# Access Compliance Report

## Public Rights-of-Way

### (Curb Ramps)

Intersection ID: 4263	Main Street: DAVIS_LAKE_PY	Cross Street: SNOWS_ENTRY_PL	Location: N
ADA ID: C2A9A344786D	Ramp Type: Directional1	Initial Pass/Fail: Fail	Overall Compliance: No
			Severity Score: 46.25

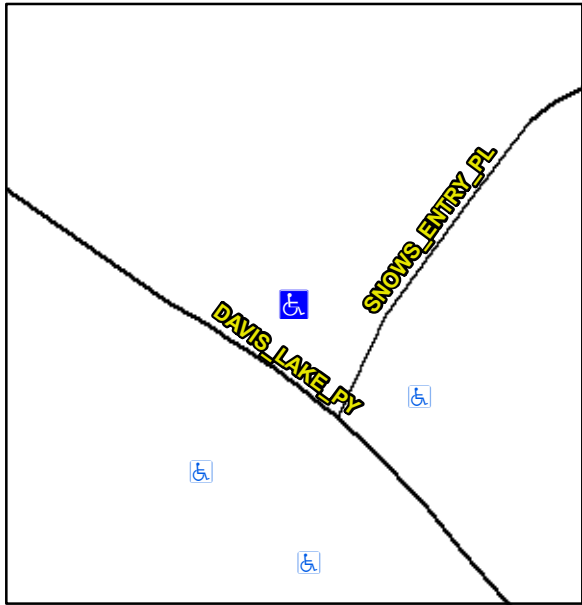
Codes/Mitigation Info/Possible Solution			Field Measurements/Component Compliance							
	Possible Solutions:		Compliance			Description			Data	
	Remove & Replace Entire Ramp.		N/A	Ramp Length (in)	64.0	N/A	Grade Break?	N/A		
			No	Ramp Width (in)	43.0	N/A	Grade Break Slope (%)	0.0		
			No	Ramp Slope (%)	13.7	N/A	Grade Break XSlope (%)	0.0		
			No	Ramp XSlope (%)	6.1					
			N/A	Flare Type LT	N/A	N/A	Flare Type RT	N/A		
			N/A	Flare Slope LT (%)	N/A	N/A	Flare Slope RT (%)	0.0		
			N/A	Flare Traversable LT?	N/A	N/A	Flare Traversable RT?	N/A		
			N/A	Landing Length (in)	0.0	N/A	DWS Provided?	N/A		
			N/A	Landing Width (in)	0.0	N/A	DWS Contrast?	N/A		
Surveyor Notes:  N/A	PROW/ADA:		N/A	Landing Slope (%)	0.0	N/A	DWS Length (in)	N/A		
	R304.5.1, R304.2.2, R304.5.3		N/A	Landing X Slope (%)	0.0	N/A	DWS Full Width?	N/A		
			N/A	Landing Curb? (Y/N)	N/A	N/A	DWS Offset LT (in)	N/A		
			N/A	Shared Landing?	N/A	N/A	DWS Offset RT (in)	N/A

N/A	Gutter Ponding?	0.0	N/A	Gutter Slope (%)	N/A		
			N/A	Gutter Lip Ht (in)	0.0	N/A	Gutter X Slope (%)	N/A		
			N/A	Painted X Walk1?	No		Road Slope (%)	8.3		
				X Walk 1 Direction	To SE		Road X Slope (%)	0.3		
				X Walk 1 Width (in)	N/A		Clear Space?	N/A		
				X Walk 1 Slope (%)	8.3	N/A	Clear Space to XWalk (in)	N/A		
Street 1 Name SNOWS ENTRY PL Stop Condition-Street 1 StopSign Street 2 Name N/A Stop Condition-Street 2 N/A				X Walk 1 X Slope (%)	0.3	N/A	Storm Grate/Utility Hazard?	N/A		
			N/A	Ramp inside XWalk1?	N/A		Storm Grate/Utility Type			
			N/A	Any Obstructions?	N/A			N/A		
				Obstruction Type		Yes	Surface Condition? (G/P)	Good		
					N/A	N/A	Curb Slope (%)	N/A		
	Total Cost:		\$	1600.00
